# ASSESSMENT OF THE 2014 INTEGRATED RESOURCE PLANS OF THE ARIZONA ELECTRIC UTILITIES

ACC DOCKET NO. E-00000V-13-0070

DRAFT - NOVEMBER 3, 2014

PREPARED ON BEHALF OF THE STAFF OF THE ARIZONA CORPORATION COMMISSION BY

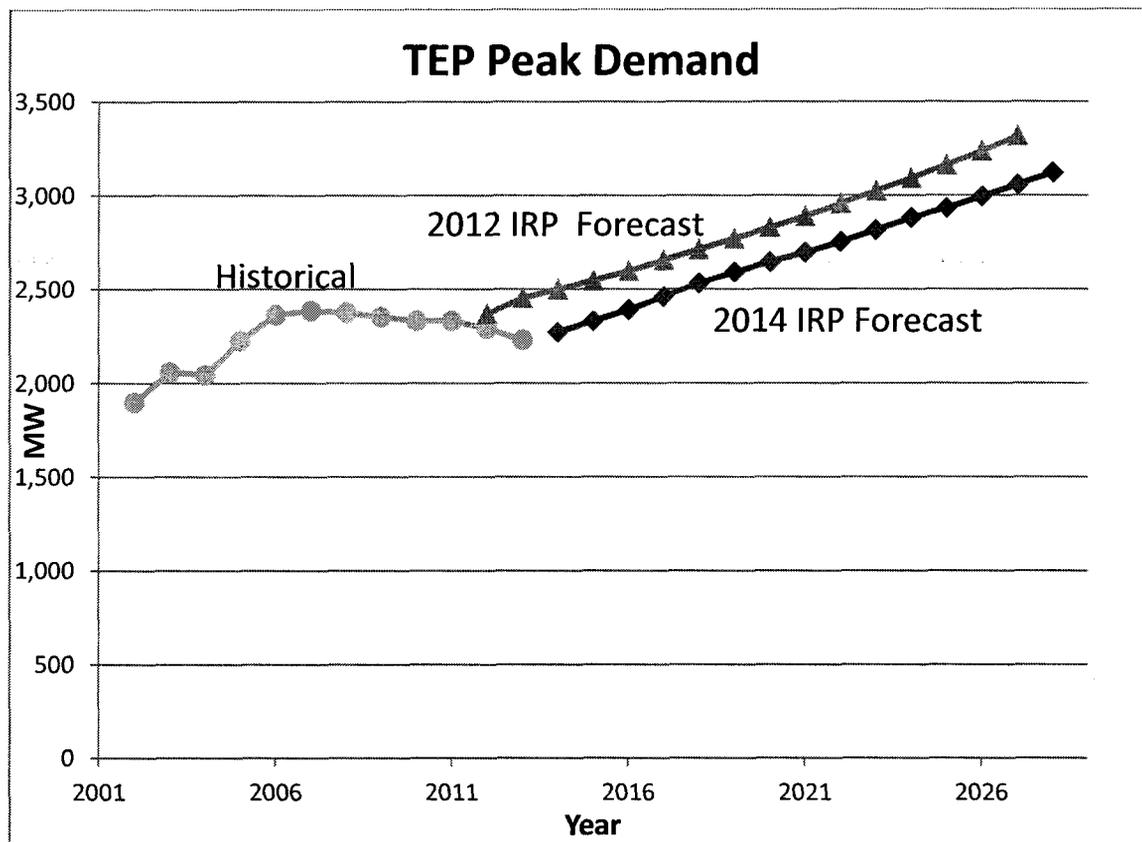
Even though APS experienced negative load growth from 2006 through 2013, the company is forecasting average load growth of more than 3% per year from 2014 through 2029. The 2012 IRP forecast was almost identical to the 2014 forecast, in that it also predicted annual load growth of about 3% per year. Although the 2012 IRP forecast accurately predicted the 2012 peak demand, it significantly overestimated the 2013 peak demand. All of this information indicates that APS’ current forecast may be overly optimistic, i.e. high.

Other information that would also indicate that APS’ 2014 forecast is overly optimistic was included in the presentation made by Western Resource Advocates (“WRA”) at the first IRP workshop on September 11<sup>th</sup>, 2014. WRA stated that population growth in Arizona has slowed in recent years, and the number of low-income residents in the state has increased.

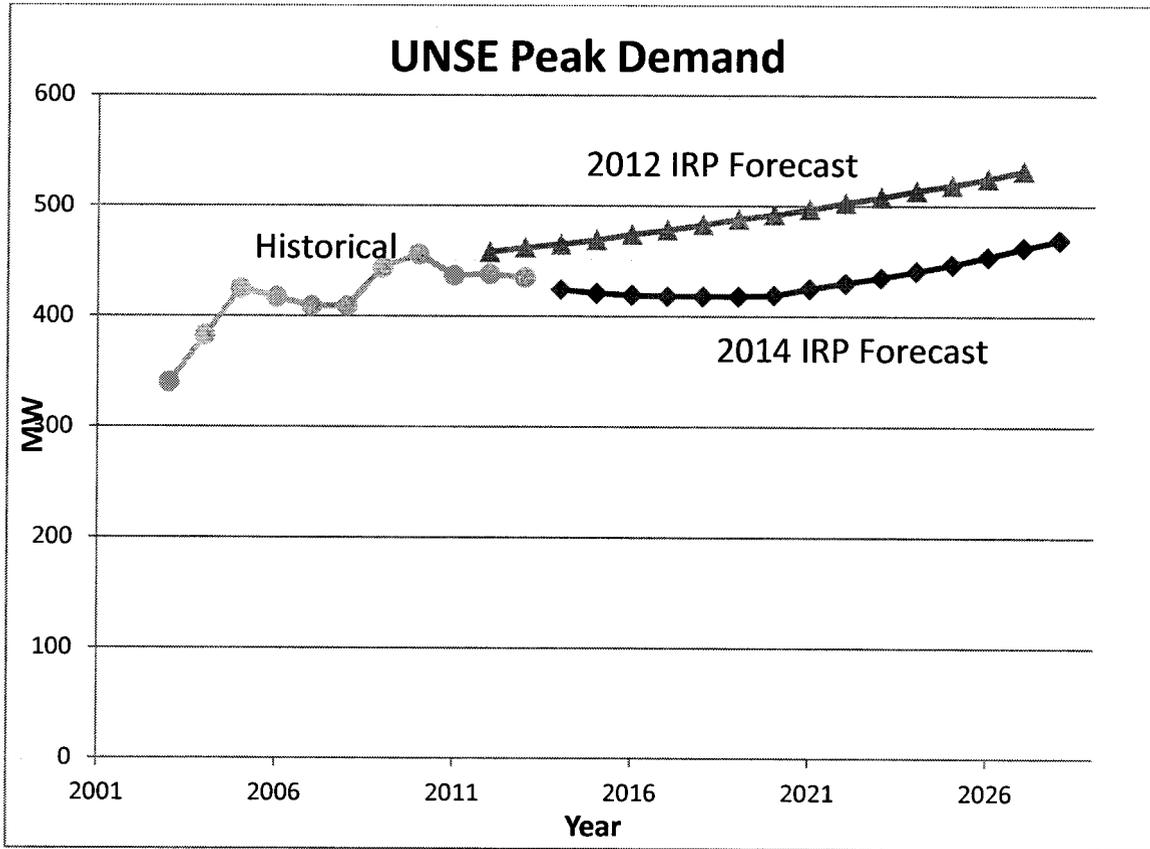
A comparison of the TEP historical peak demand, 2012 IRP forecast and the 2014 IRP forecast is remarkably similar to the comparison of the APS information discussed on the previous page. TEP experienced negative load growth from 2006 through 2013, yet the company now predicts constant future load growth averaging over 2% per year. As with APS, TEP's 2012 forecast predicted the 2012 peak demand fairly well, but significantly over-estimated the 2013 peak demand. It appears that the TEP 2014 forecast may also be overly optimistic concerning future load growth.
